**K&A 578-95-01**

**SUBJECT:** Dixie Lime and Stone Company  
Sumterville Mine - Nonmetallic Mineral Processing Plant  
Air Construction/Operation Permit Application  
FDEP File Nos. AC60-275111, AO60-275112  
**Response to Request for Additional Information dated August 25, 1995**

PROCESS FLOW DIAGRAM  
CEDAR RAPIDS CRUSHER

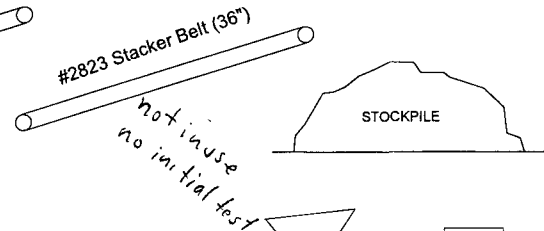
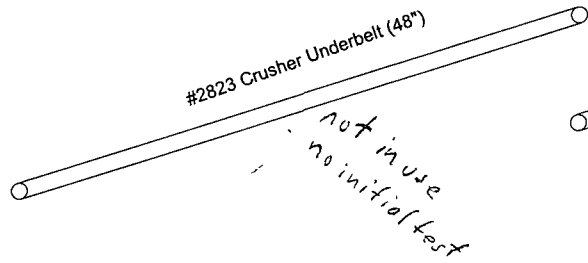
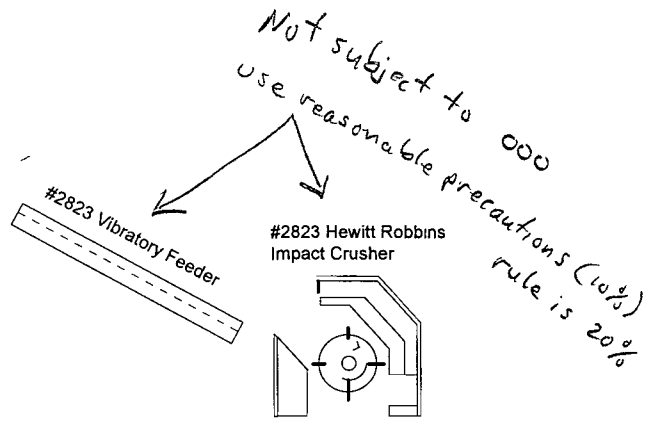
8. **Identify in the process flow diagram, by unique designation, each piece of equipment listed.**

Revised process flow diagrams are included as Attachment 2.

PROCESS FLOW DIAGRAM  
 POWERSCREEN

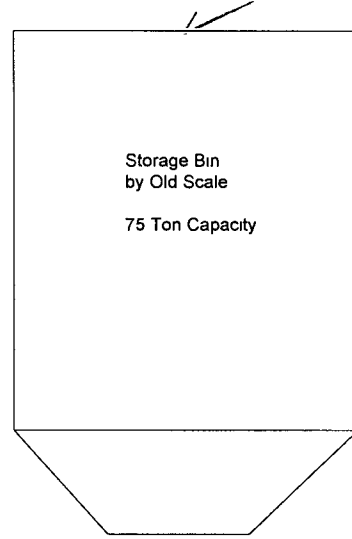
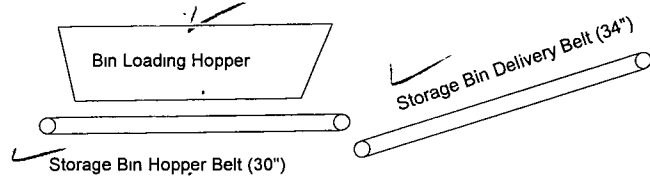
9. **Please identify the storage bin in the process flow diagram.**

The storage bin is separate from the portable crushing units. A process flow diagram for the storage bin and associated conveyors is included with Attachment 2.
